SHEET TITLE
SITE PLANS
PROJECT ADDRESS
98 CUTLER ROAD,
CLONTARF

CLIENT
BOWES HOUSE
DOCUMENTATION
-

SCHEDULE OF MODIFICATIONS SOUGHT

03 - Level 3
1 : 100

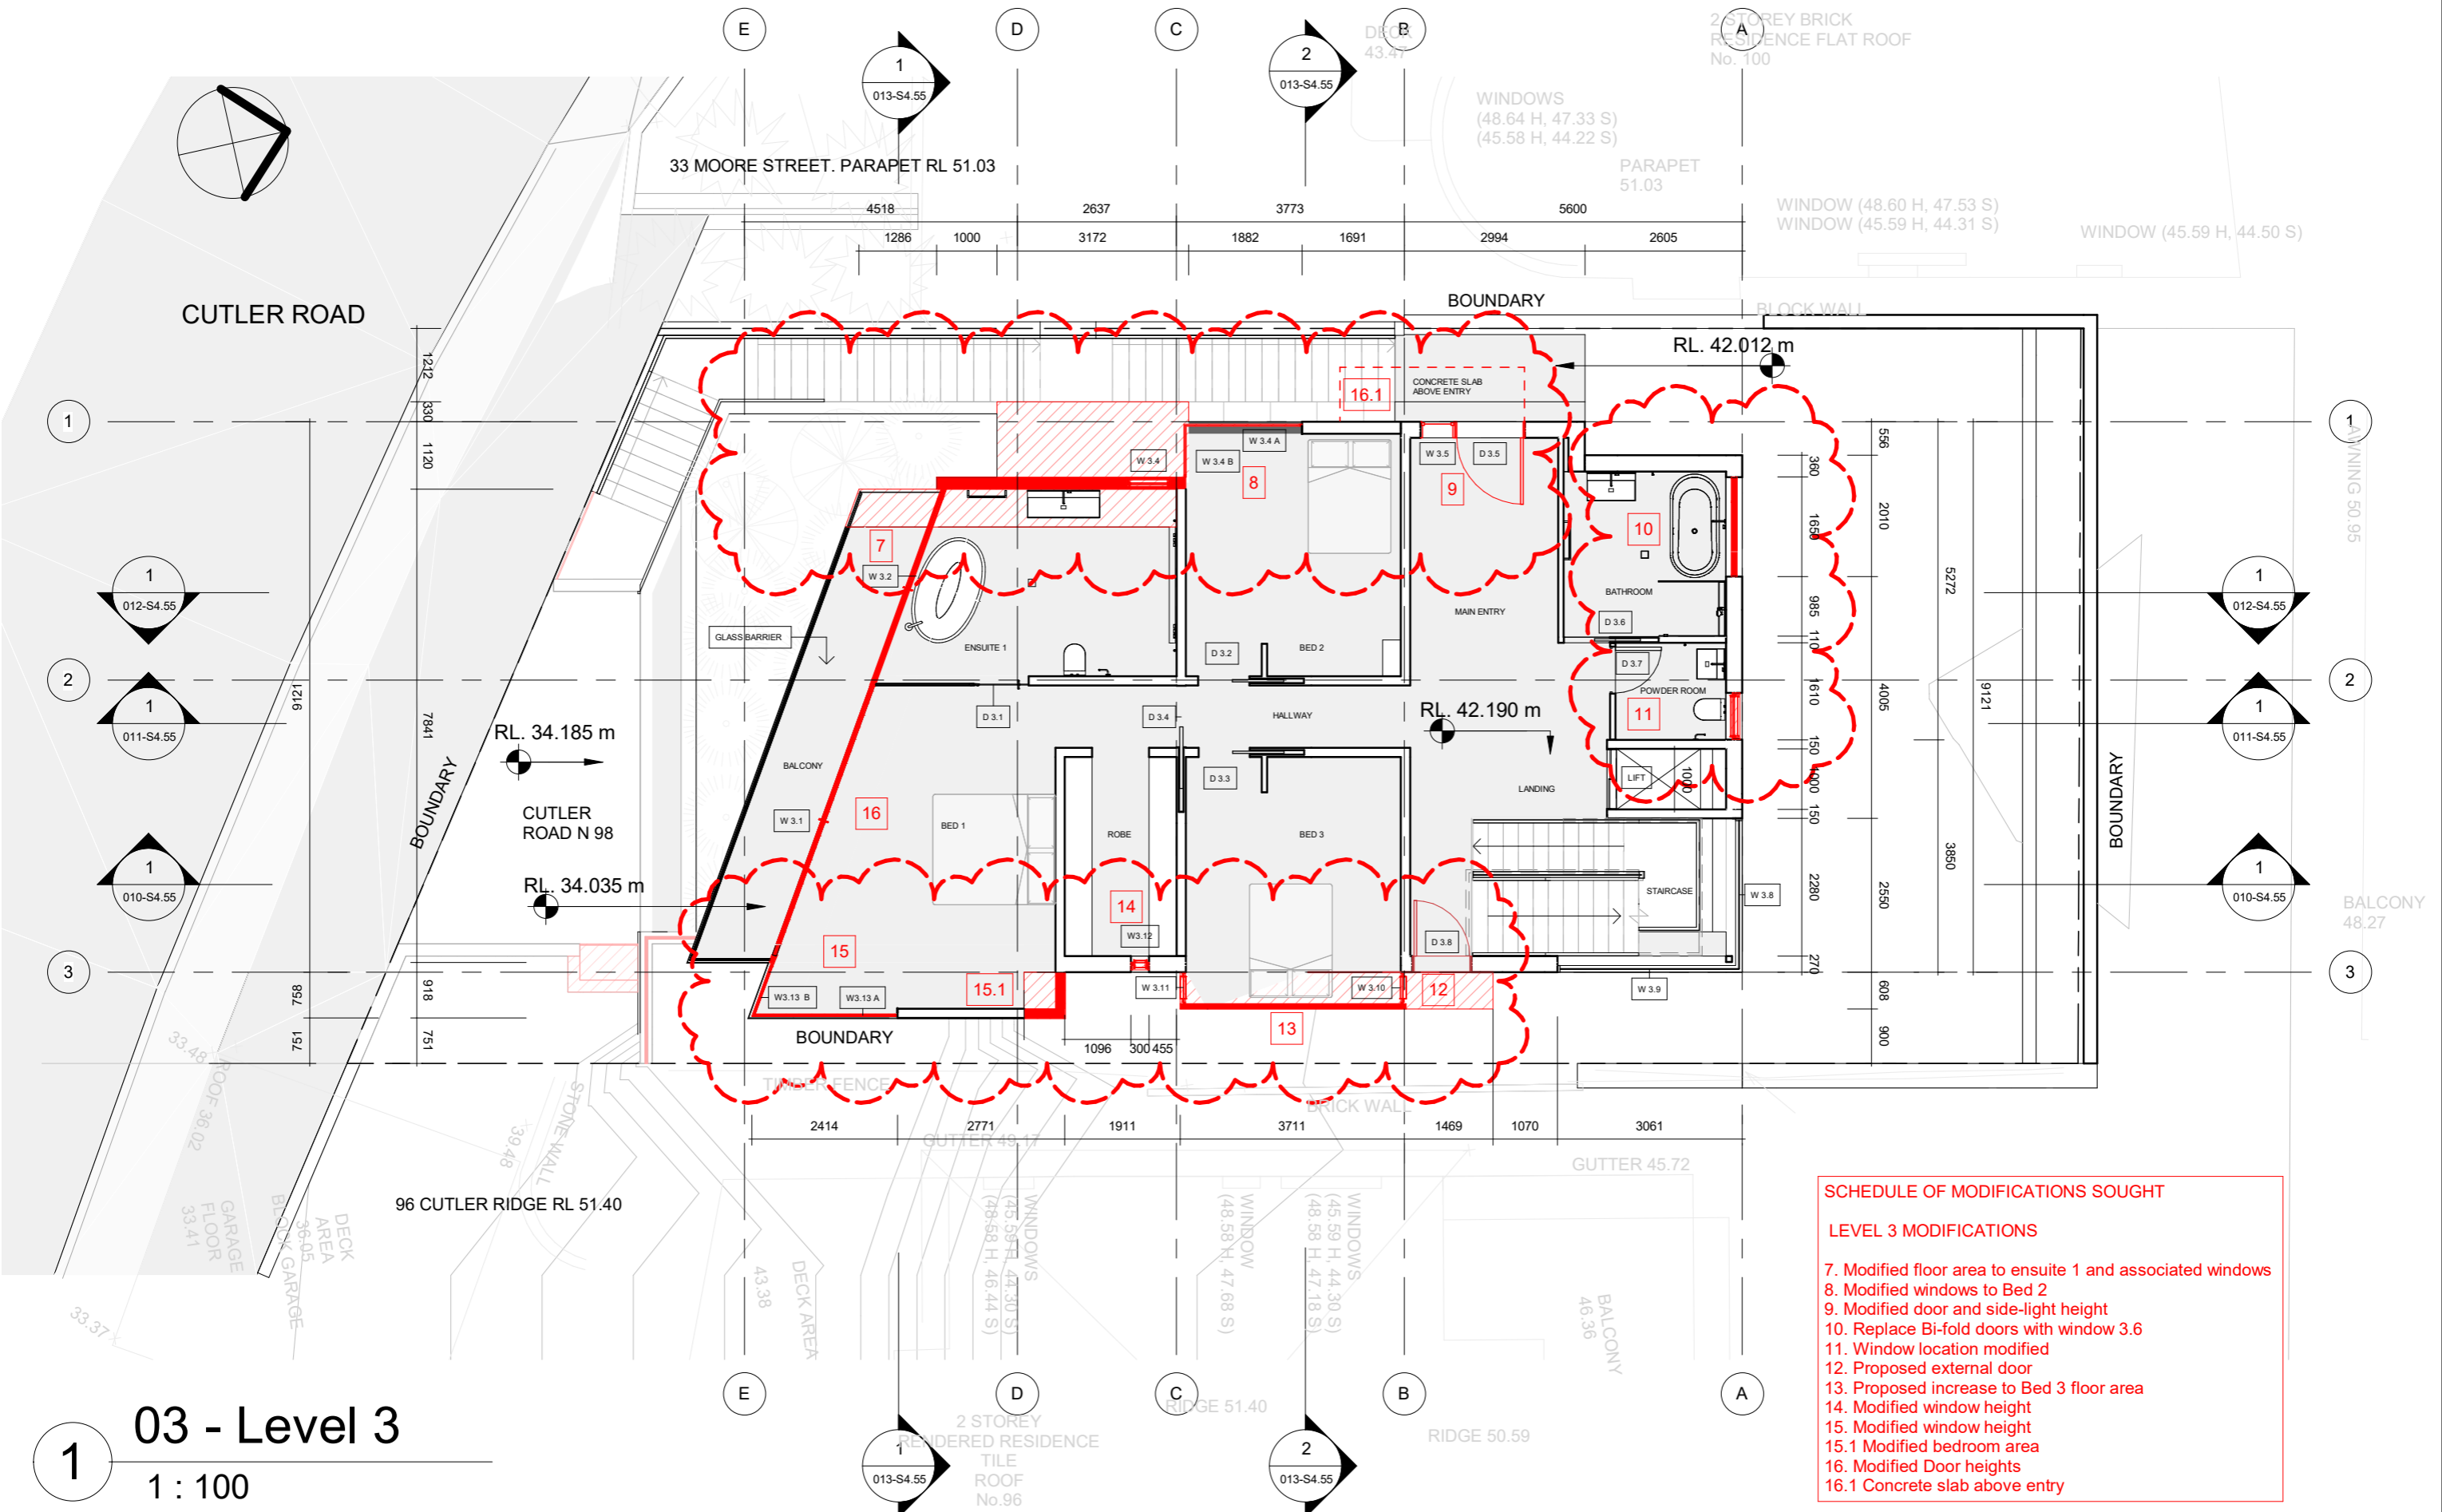
- SCHEDULE OF MODIFICATIONS SOUGHT**
- LEVEL 3 MODIFICATIONS**
- 7. Modified floor area to ensuite 1 and associated windows
 - 8. Modified windows to Bed 2
 - 9. Modified door and side-light height
 - 10. Replace Bi-fold doors with window 3.6
 - 11. Window location modified
 - 12. Proposed external door
 - 13. Proposed increase to Bed 3 floor area
 - 14. Modified window height
 - 15. Modified window height
 - 15.1 Modified bedroom area
 - 16. Modified Door heights
 - 16.1 Concrete slab above entry

02 - Level 2
 1 : 100

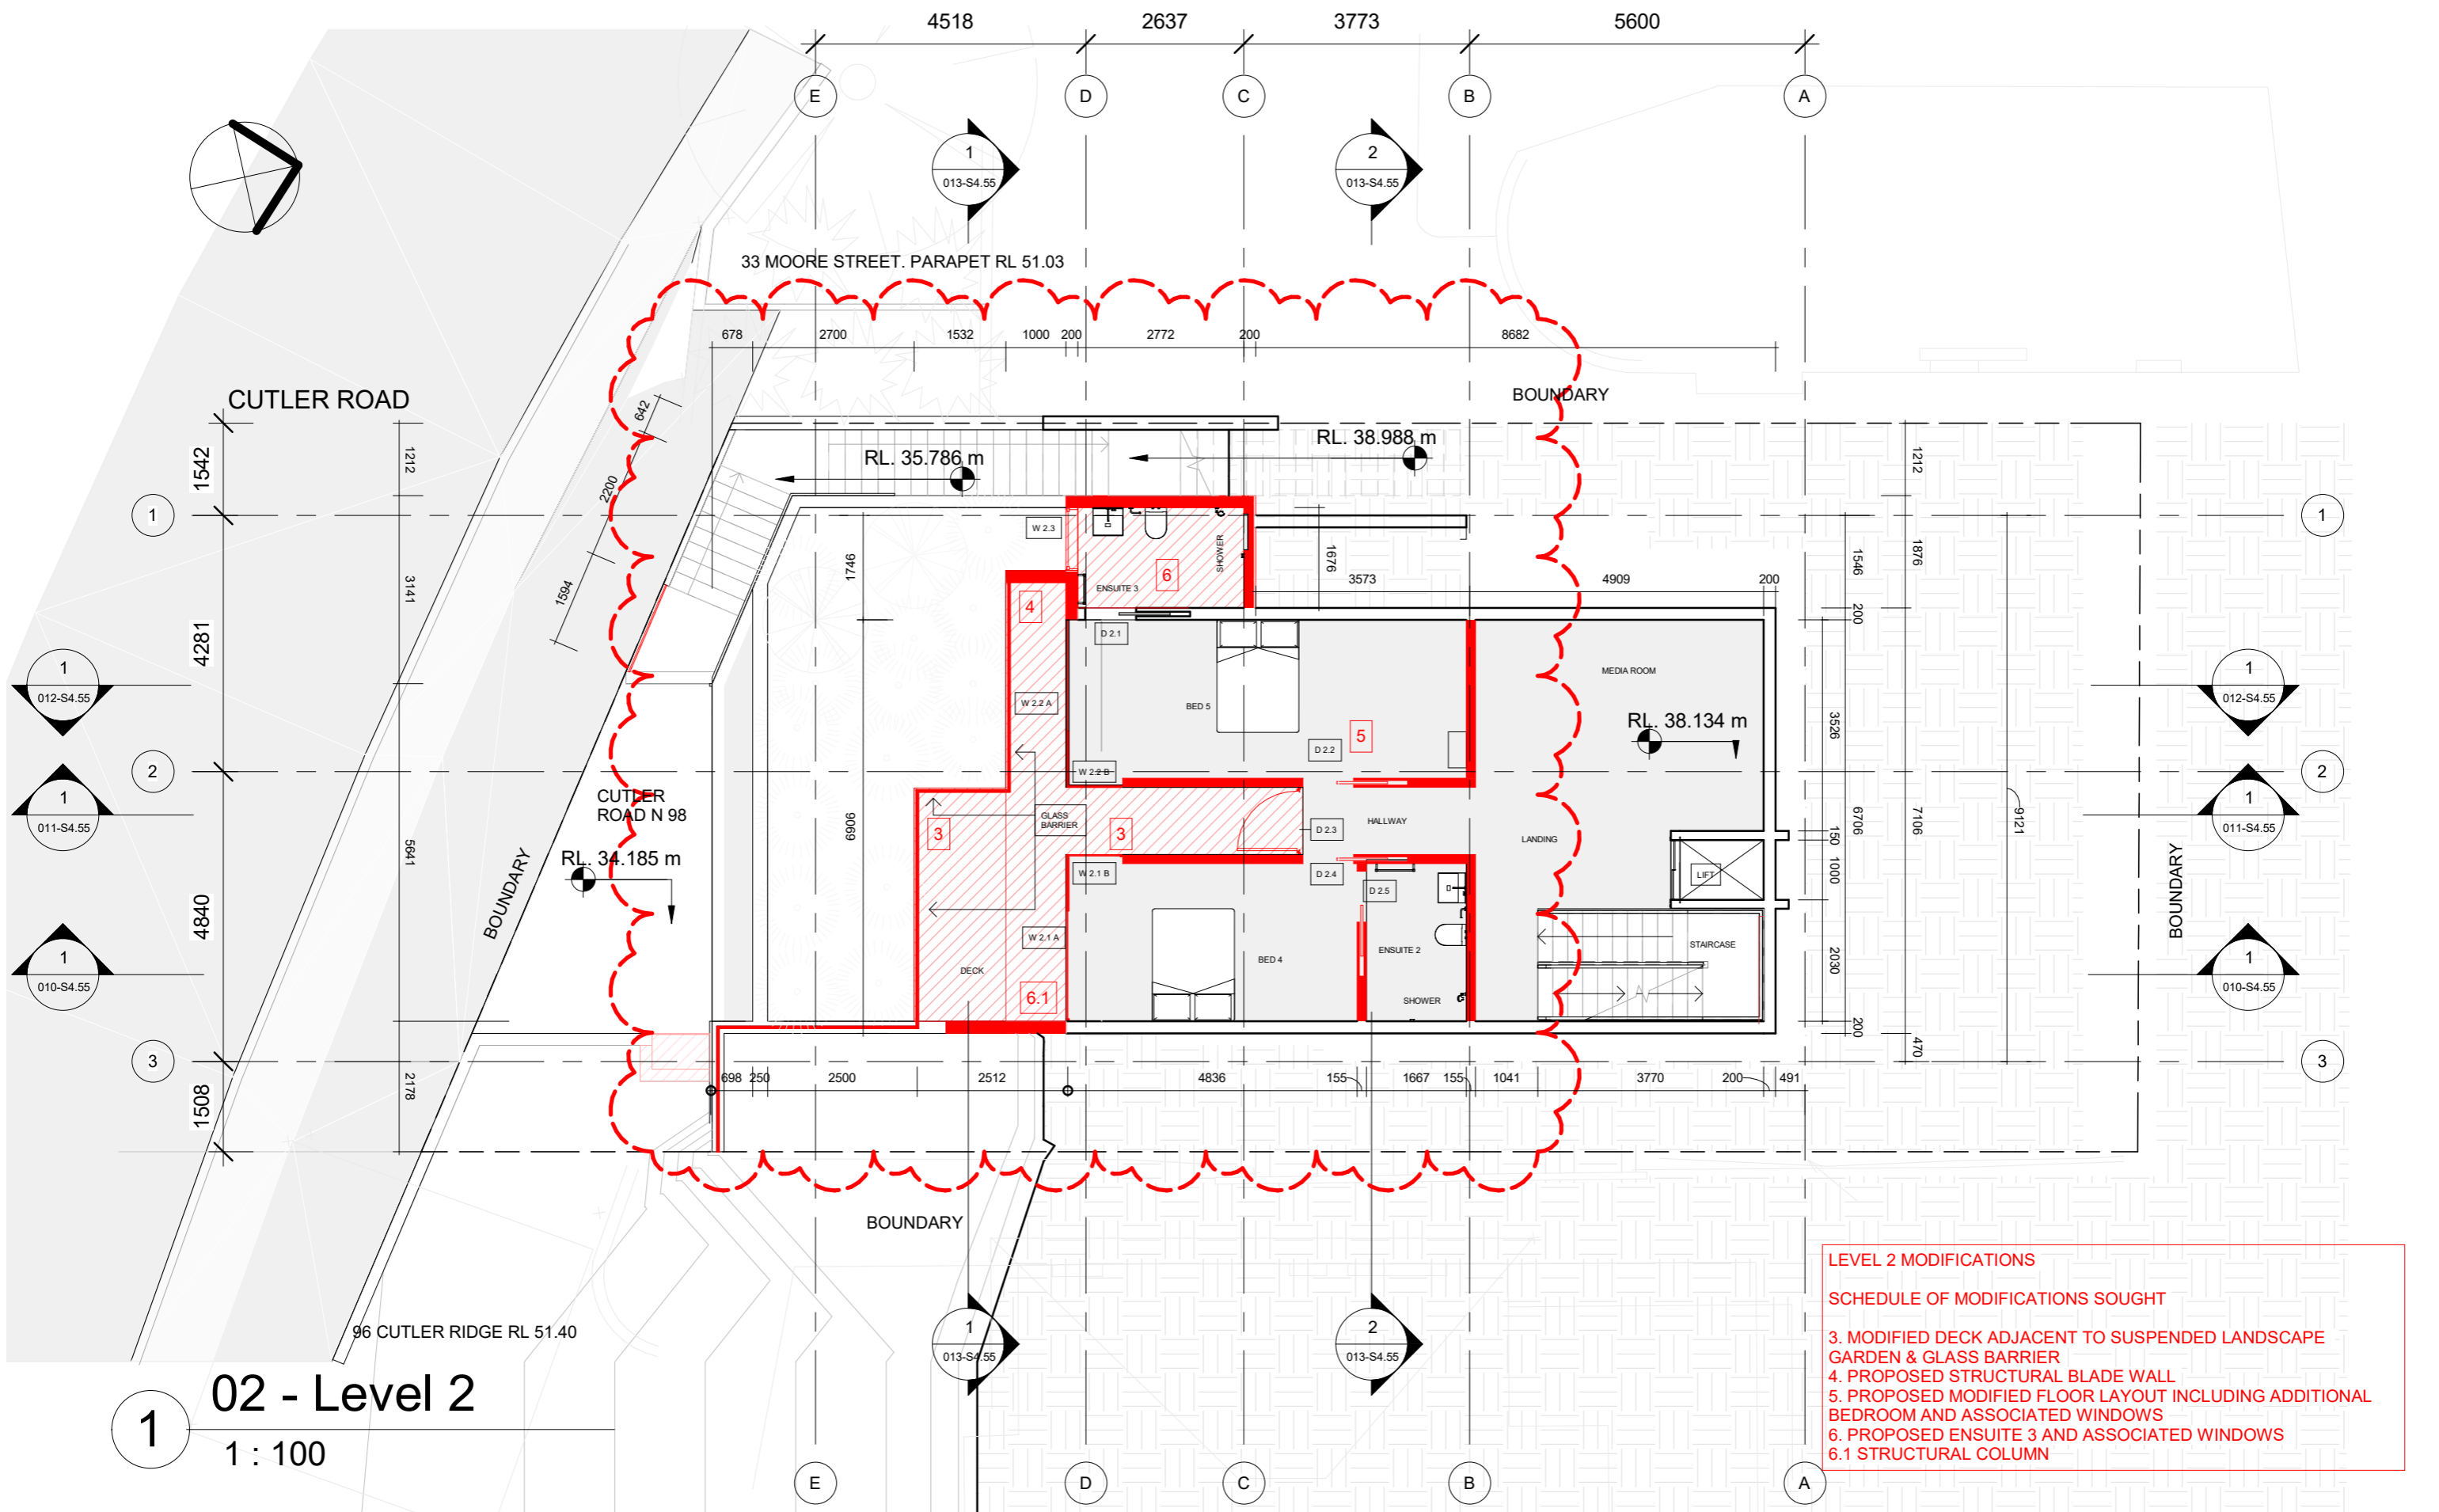
- 3. MODIFIED DECK ADJACENT TO SUSPENDED LANDSCAPE GARDEN & GLASS BARRIER
- 4. PROPOSED STRUCTURAL BLADE WALL
- 5. PROPOSED MODIFIED FLOOR LAYOUT INCLUDING ADDITIONAL BEDROOM AND ASSOCIATED WINDOWS
- 6. PROPOSED ENSUITE 3 AND ASSOCIATED WINDOWS
- 6.1 STRUCTURAL COLUMN
